Docket Item # 6
BAR CASE # 2009-0172

ISSUE: Alterations
APPLICANT: St. Paul's Episcopal Church
LOCATION: 228 S. Pitt Street
ZONE: RM/Residential

BAR CASE #2009-0172

Figure 3. Proposed Norton Hall doorway & cloister entry gate.

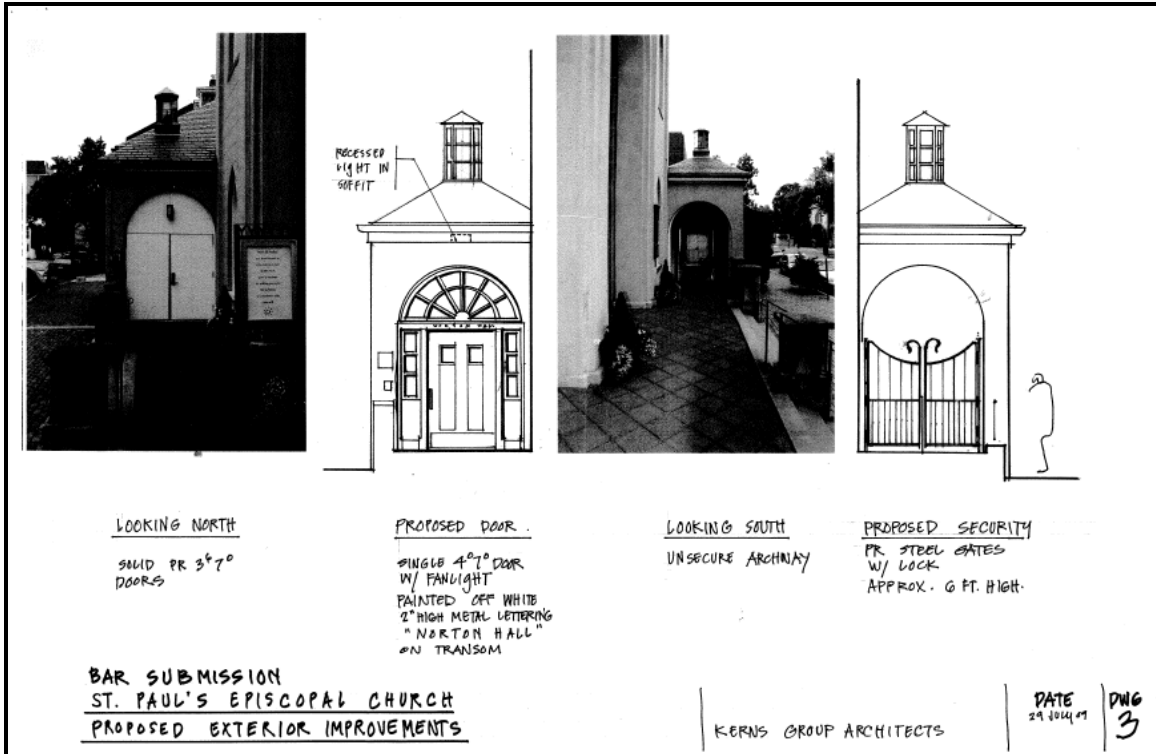
In 1996, the Board approved replacement of all of the plywood transoms along the front entrances into the main church sanctuary with glass transoms replicating historic glass transoms with gothic mullions that Staff found evidence to support were originally on the building. (BAR96-0223) It is in this same manner that the applicant has proposed replacement of the doorway leading into Norton Hall with a single door, side lights and fanlight transom. As stated in the *Design Guidelines*, “Exterior doors and surrounding details should complement the architecture of the structure and not detract away from it.” It is the opinion of Staff that the proposed doorway is stylistically compatible with a similar doorway on the Duke Street elevation of the property in addition to complementing the 1996 transom alterations. The proposed light above the Norton Hall door will be recessed into the soffit.

Figure 4. Detail of proposed iron work and columns.

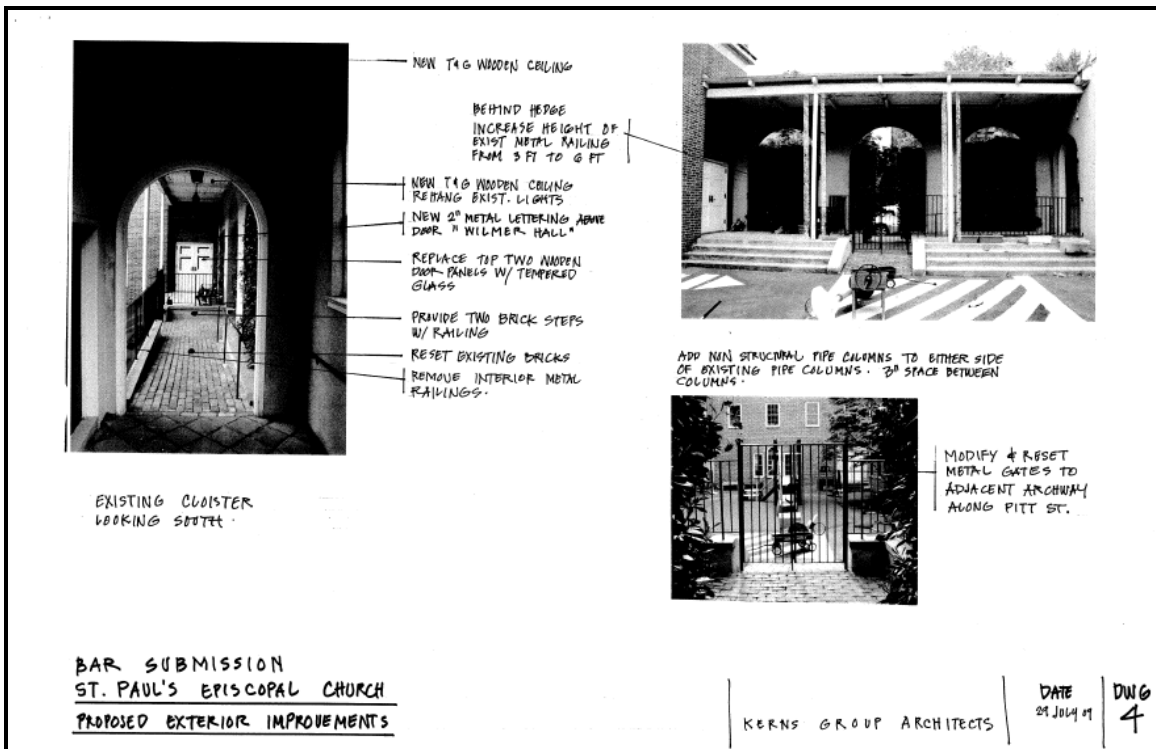
As stated by the architect, Thomas L. Kerns FAIA, "the goal of the project is to improve the security and sense of welcome for the existing buildings that flank St. Paul's Episcopal Church." The majority of the work revolves around the cloister located to the south of the church which was constructed in 1955. The cloister is minimally visible to the streetscape due to an existing mature hedge which will mostly obscure from view the new six foot wrought iron fence and security gate. The applicant has indicated that the intention of the new columns is to add visual mass and weight and to improve their function of dividing the playground space from the walkway of the cloister. According to the *Design Guidelines*, "ornamental iron or metal fences and gates are appropriate for late 19th and early 20th century Victorian structures." Staff finds the new steel gate dividing the porch and the cloister to be appropriate both aesthetically and in massing.
